ADDENDUM 4

ADDENDUM DATE: July 16th, 2019

PROJECT: Asheboro City Schools – HVAC Installation - Gymnasiums
Asheboro, NC 27203

MECHANICAL SCHEDULES AND DETAILS

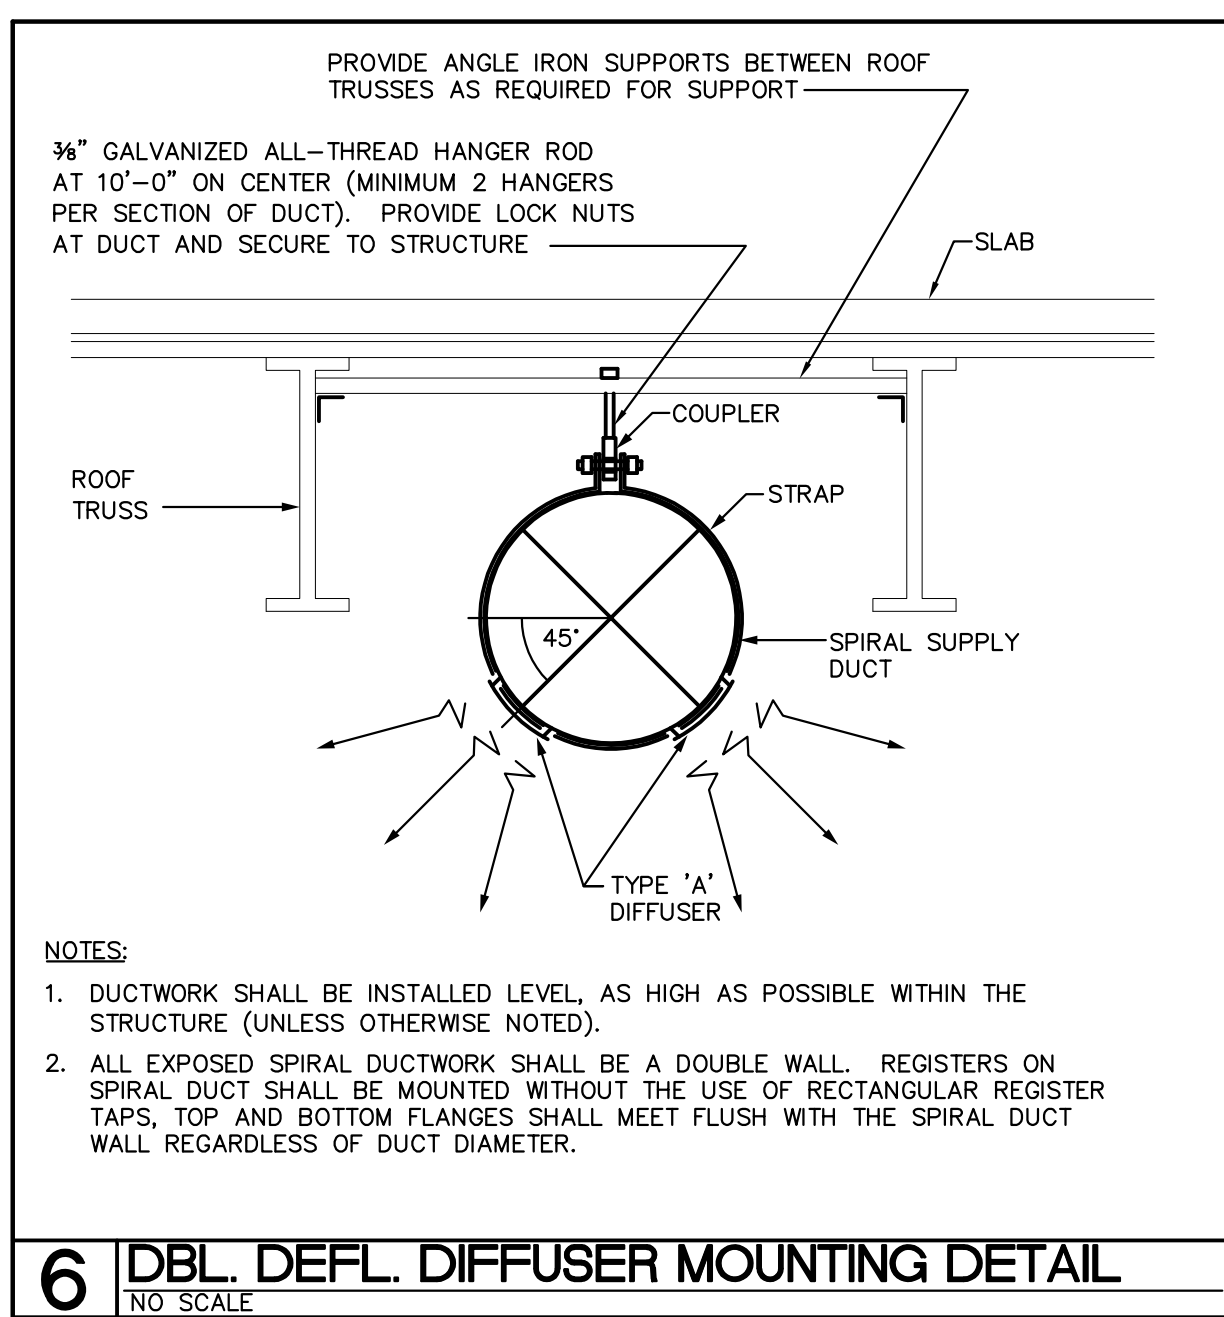
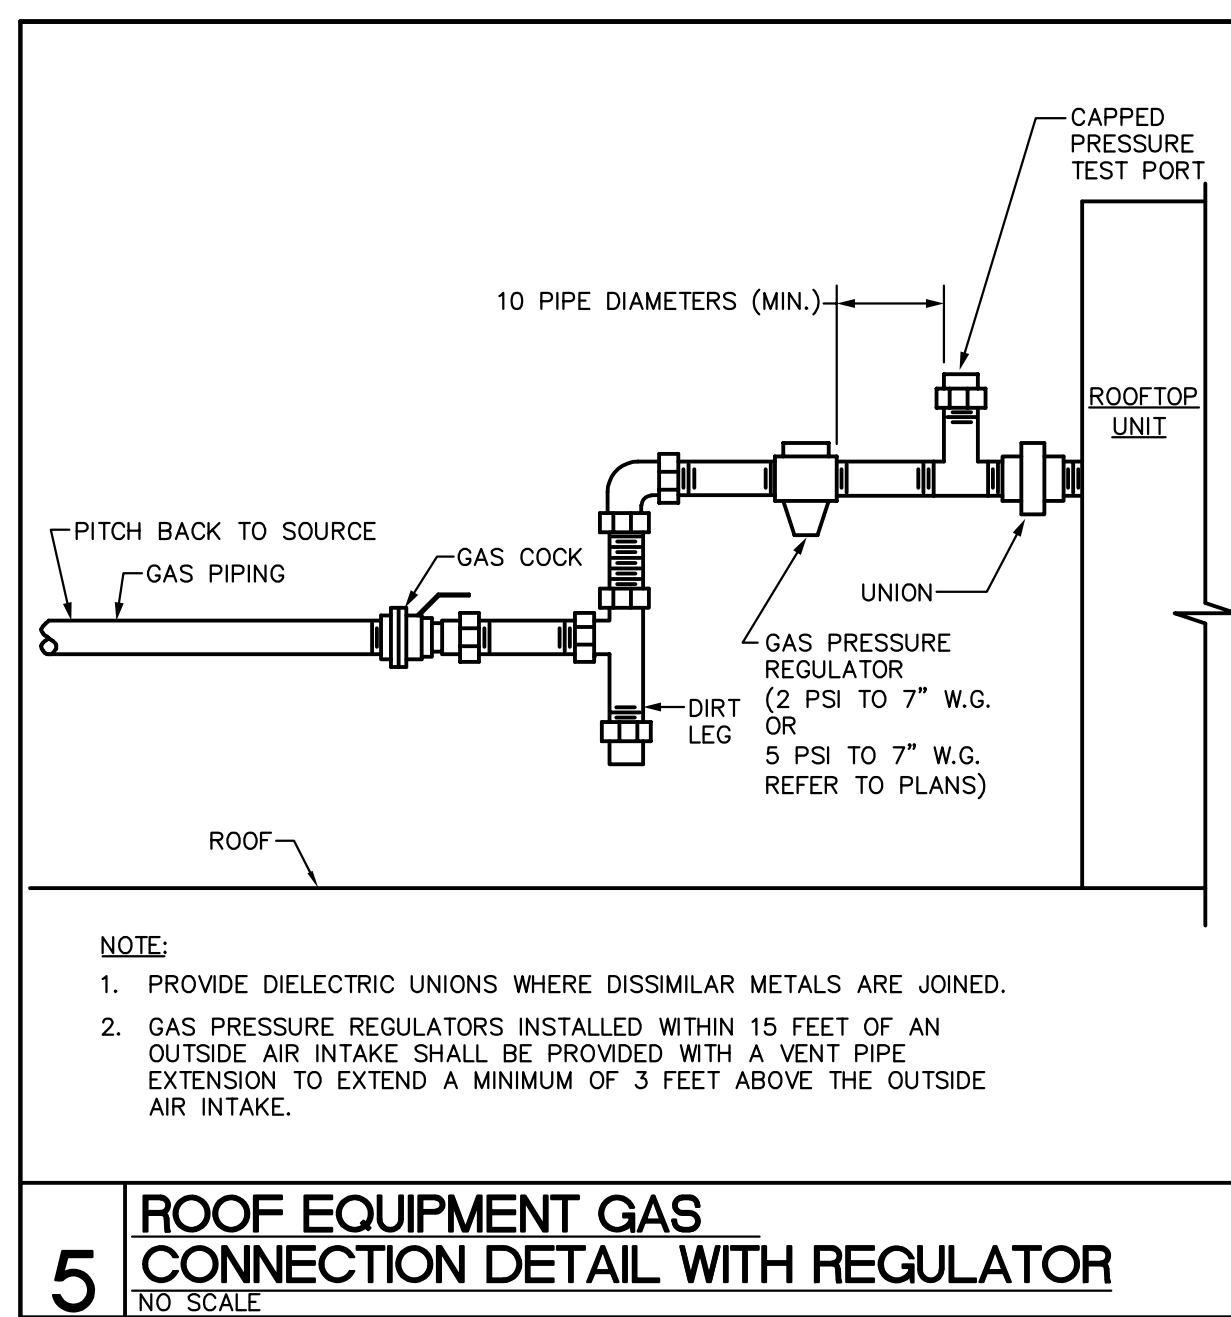
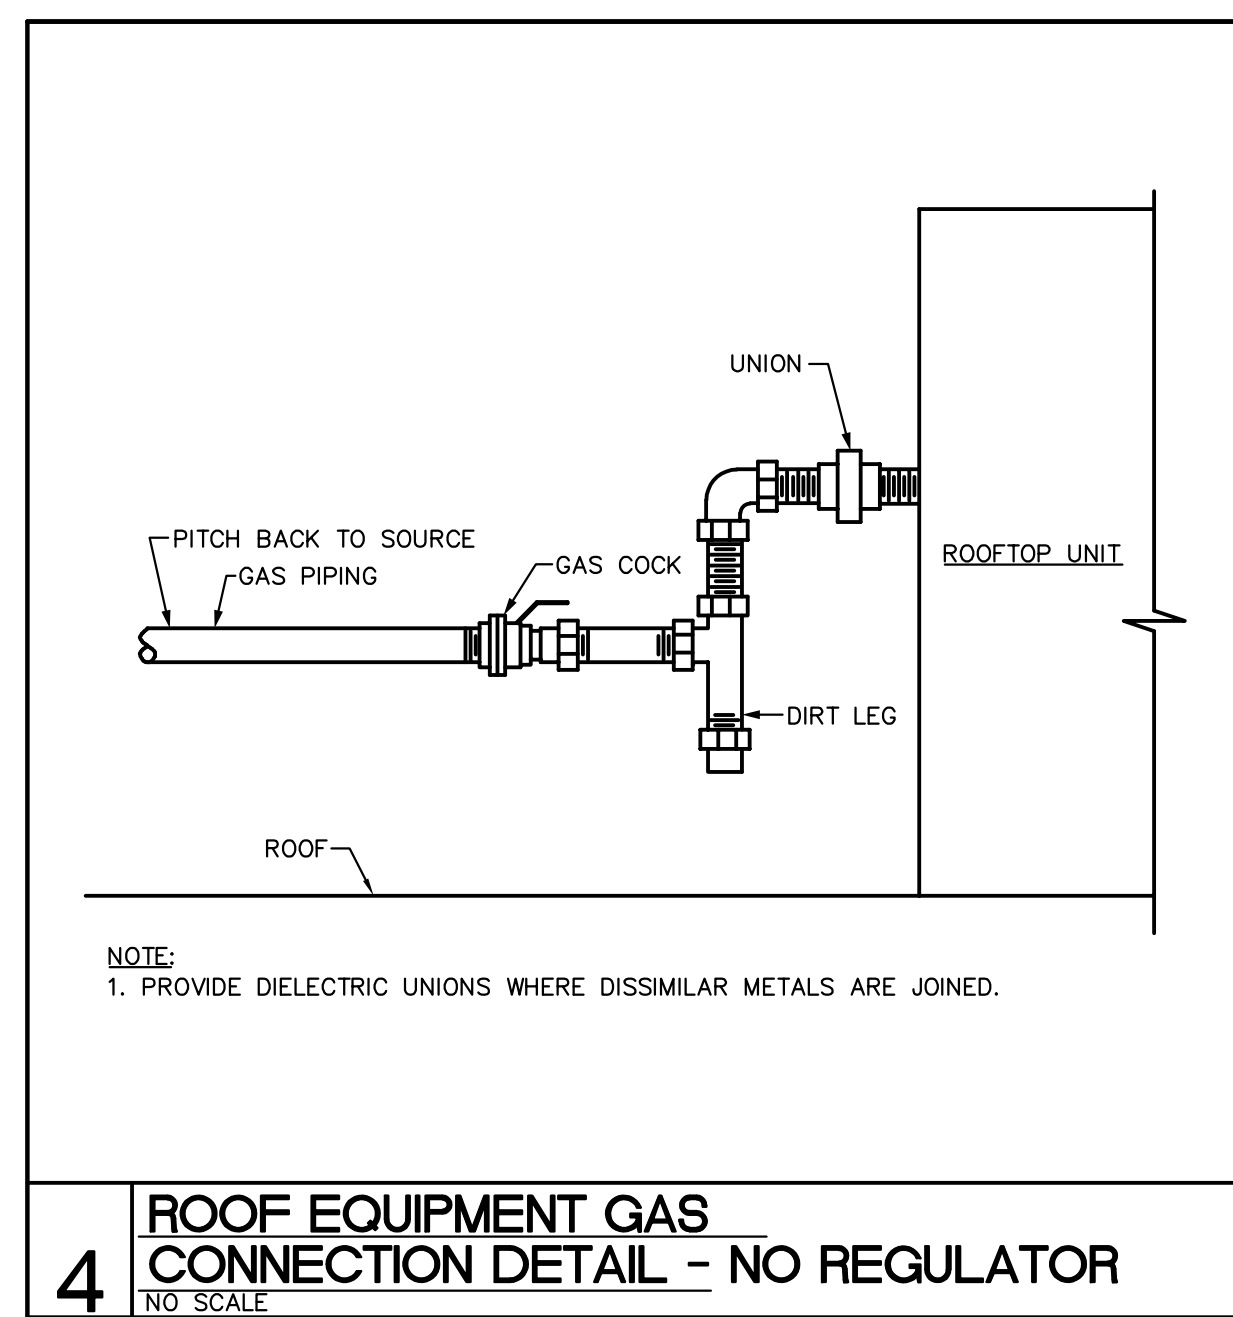
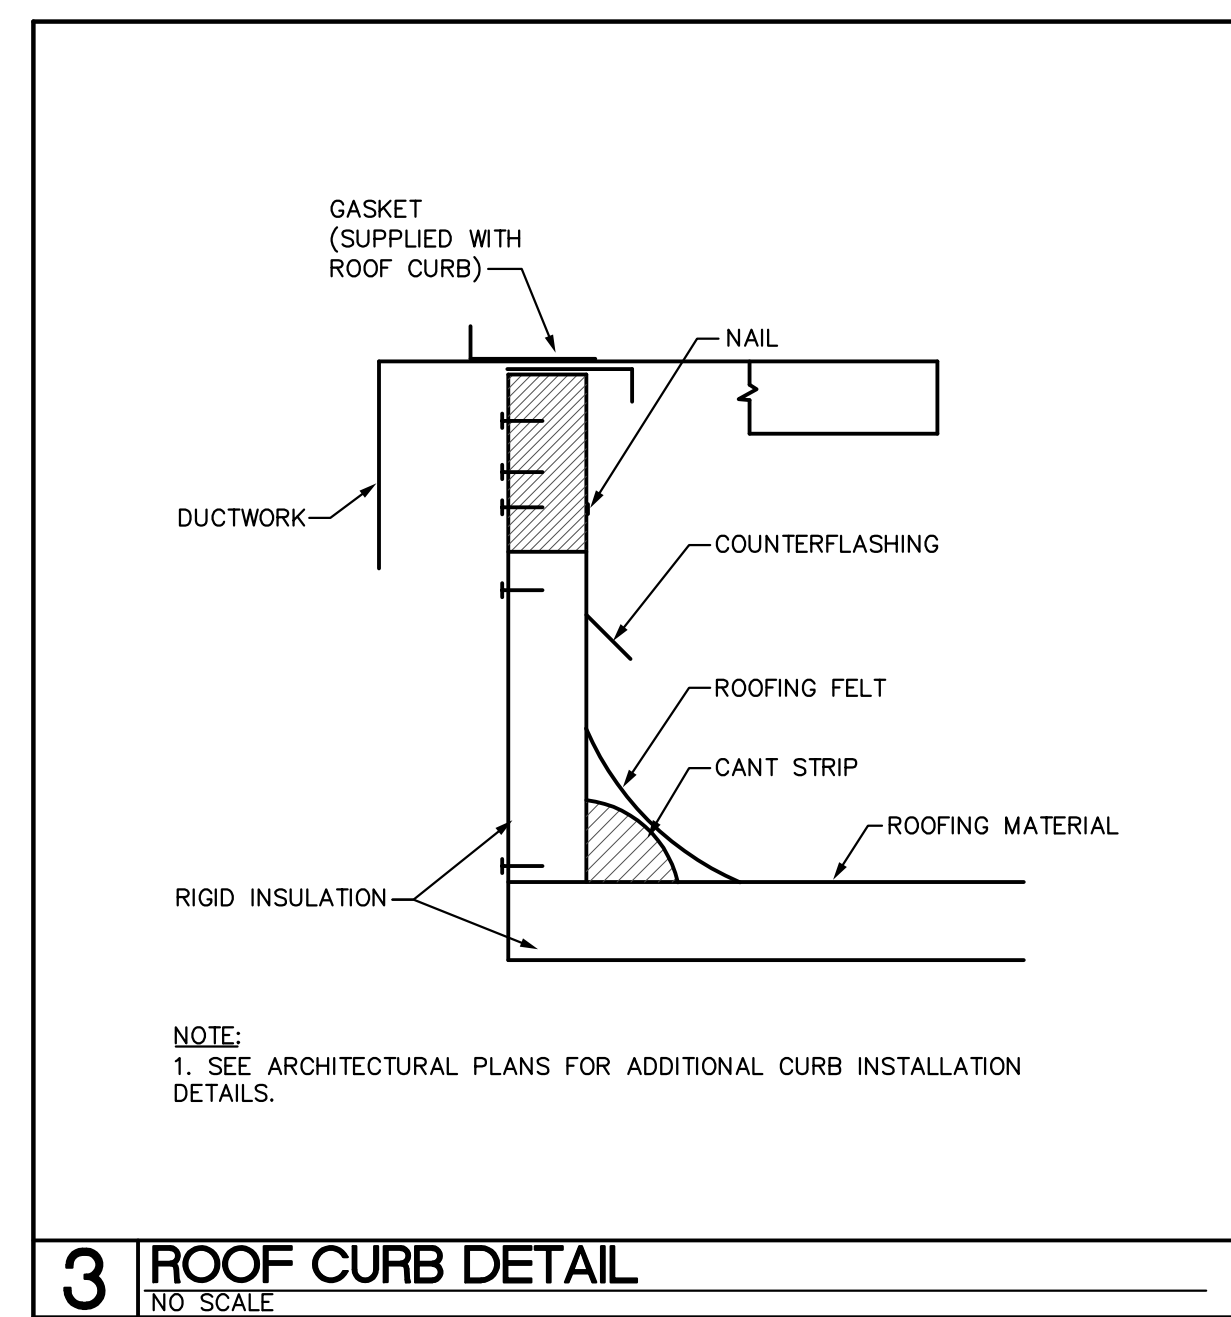
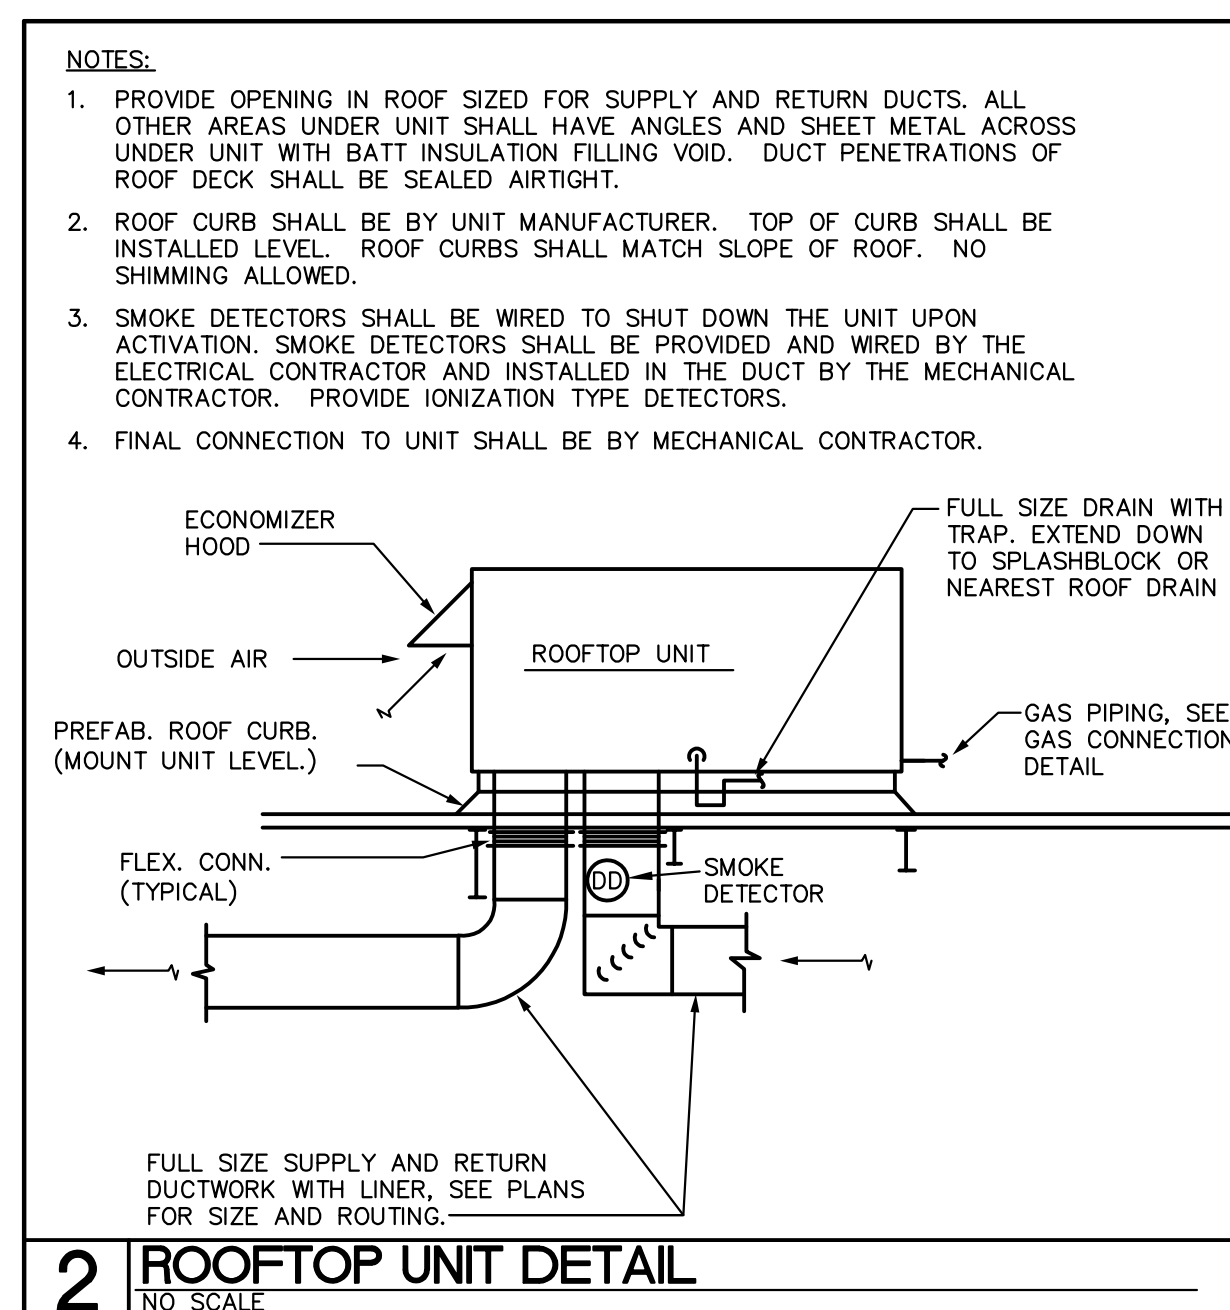
- Item 6 **REPLACE:** Sheet M0-02, M1-11A, M1-11B, and M1-11C. Revised sheet M0-02 provides information on ventilation calculations and outside air delivery amounts. Revised sheets M1-11A, M1-11B, and M1-11C provide information on added carbon monoxide detection and relocation of a plumbing vent.
